# Illinois Power Company

U-0644  
P23-83(06-17)-L

June 17, 1983

Subject: Clinton Power Station Unit 1  
Humphrey Concerns

FIGURE 1

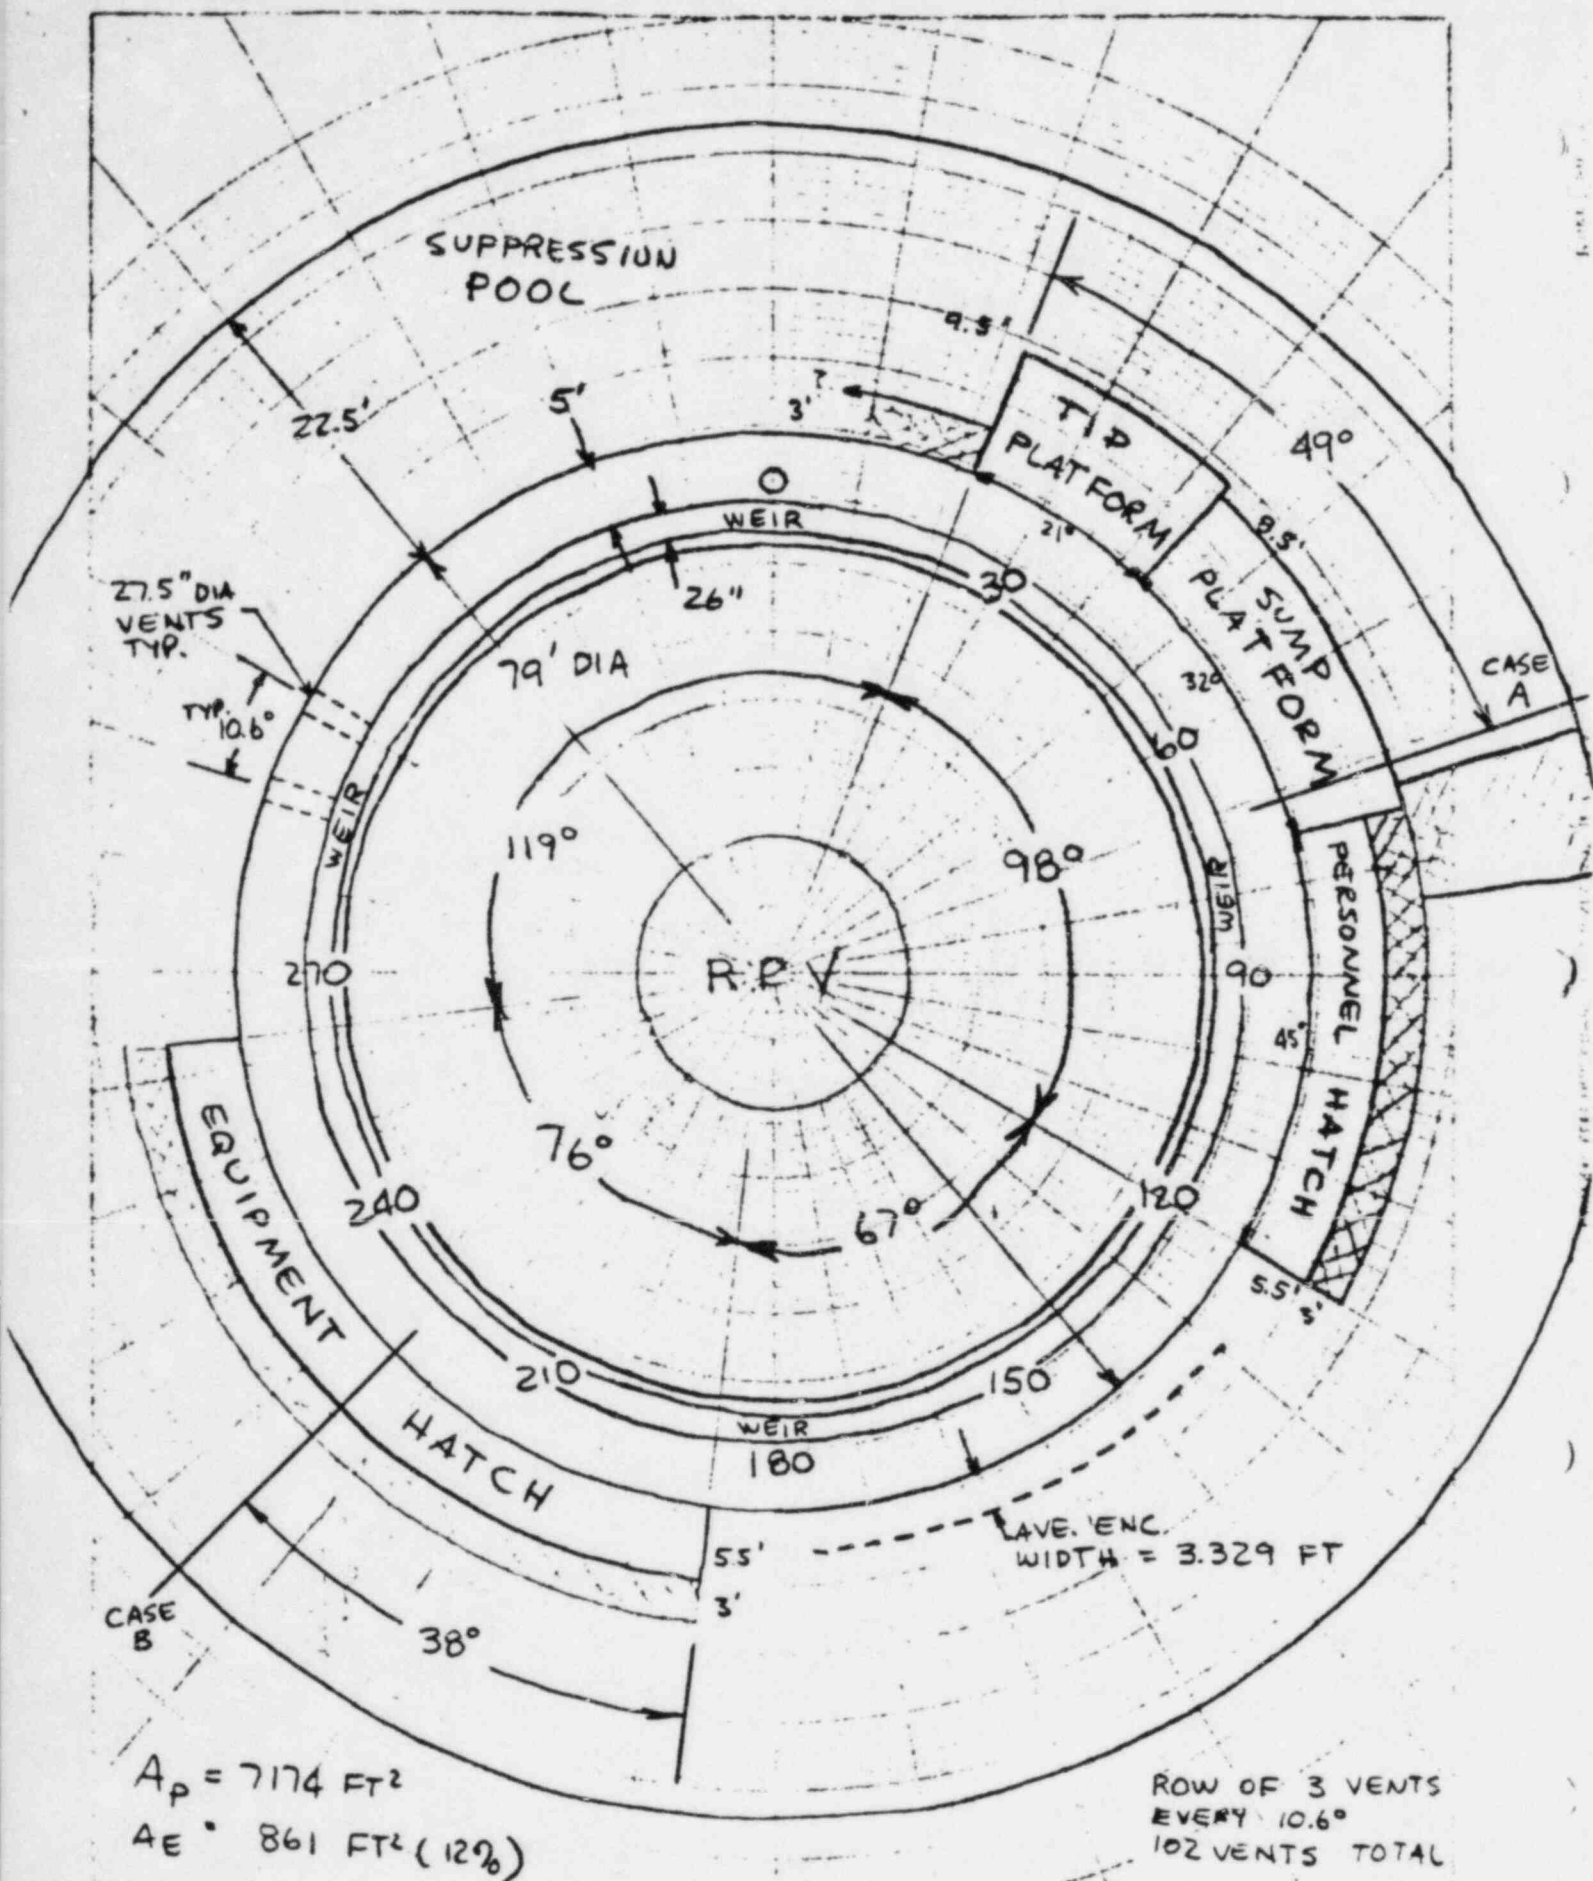
- 1.1 Presence of local encroachments such as the TIP platform, the drywell personnel airlock and the equipment and floor drain sumps may increase the pool swell velocity by as much as 20 percent.
- 1.2 Local encroachments in the pool may cause the bubble break through height to be higher than expected.
- 1.4 Piping impact loads may be revised as a result of the higher pool swell velocity.

The modified SOLAVOL computer code was used to determine the effect of the Clinton encroachments on the pool swell transient. The Clinton suppression pool geometry is shown in Figure 1. The most severe encroachment size from a pool swell standpoint is the smallest encroachment where breakthrough does not occur. Pool swell loadings are proportional to the impact velocity and density; pool velocities increase as the encroachment size decreases. However, if breakthrough occurs, the impact density decreases which reduces the resultant loading. The circumferential extent of the encroachment also has an effect on the pool swell transient. The worst case would be at the circumferential midpoint of the encroached circumferential length. This is because the bubble pressure is increased due to the encroachment until the time that coalescence and pressure relief with the adjacent bubbles occur. The following cases were evaluated with these factors in mind. The sump platform, an 8.5 foot encroachment, was evaluated with FSAR assumptions at the location shown in Figure 1 as case A. Breakthrough did not occur in this case, but the resultant loading was not very severe. The equipment hatch, a 5.5 foot encroachment, was evaluated at the location shown in Figure 1 as case B. Breakthrough did not occur early enough to avoid impact on the HCU floor. This 5.5 foot encroachment case is the most severe case due to the larger velocities in the pool relative to the 8.5 foot encroachment. The details of the 5.5 foot encroachment case follow.
